SURVEY FOR SUBLOT No. 24 IN THE MADISON PALISADES-ON-THE  
GRAND RIVER SUBDIVISION, AS RECORDED IN PLAT BOOK VOL. F PG. 54  
PART OF TRACTS No. 7 & 10  
MADISON TWP.  
LAKE COUNTY, OHIO

SURVEY FOR  
JOHN W. WATTS  
SURVEYED BY  
WILLIAM G. HOWES  
R.S. No. 68862  
7-12-87  
JOB No. A-95  
A-98

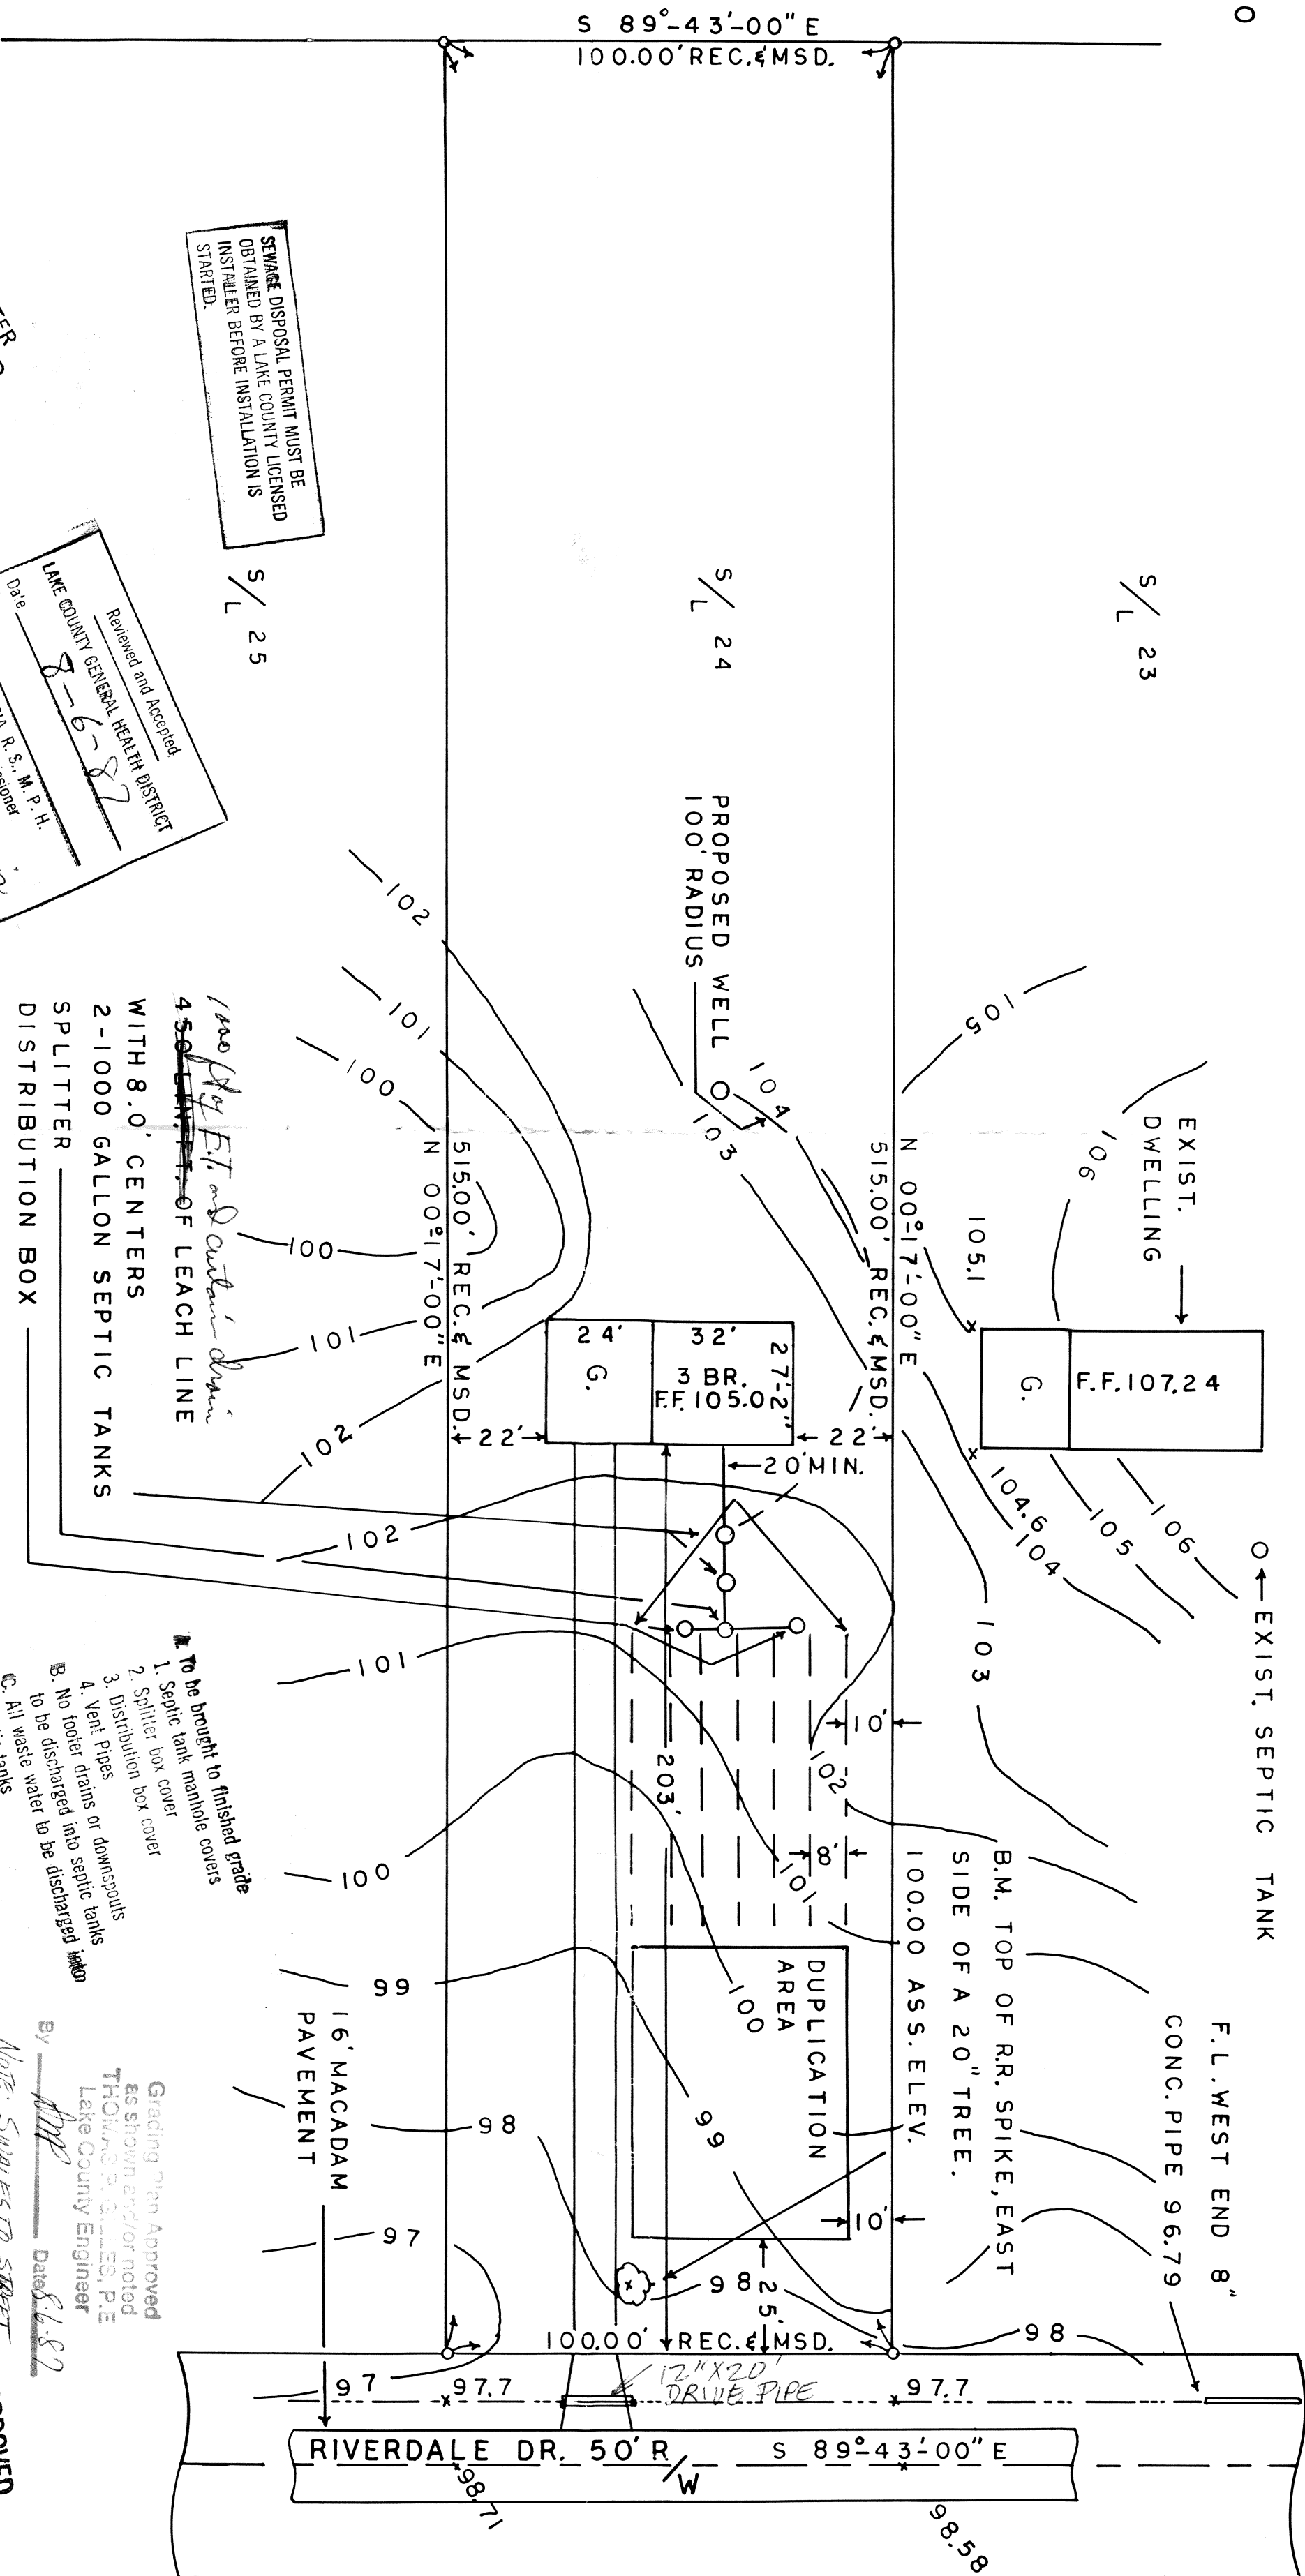
SEWAGE DISPOSAL PERMIT MUST BE  
OBTAINED BY A LAKE COUNTY LICENSED  
INSTALLER BEFORE INSTALLATION IS  
STARTED.

LOW YIELD WATER  
FIXTURES REQUIRED  
ON ALL  
Shower Head  
Toilet

Reviewed and Accepted  
LAKE COUNTY GENERAL HEALTH DISTRICT  
Date: 8-6-87  
JOEL LUKA, R. S., M. P. H.  
Health Commissioner  
BY: [Signature]

Grading Plan Approved  
as shown and/or noted  
THOMAS P. JONES, P.E.  
Lake County Engineer  
By: [Signature] Date: 8.6.87

APPROVED  
MADISON TWP. ZONING  
Permit: 12136  
Zoning Inspector: [Signature]
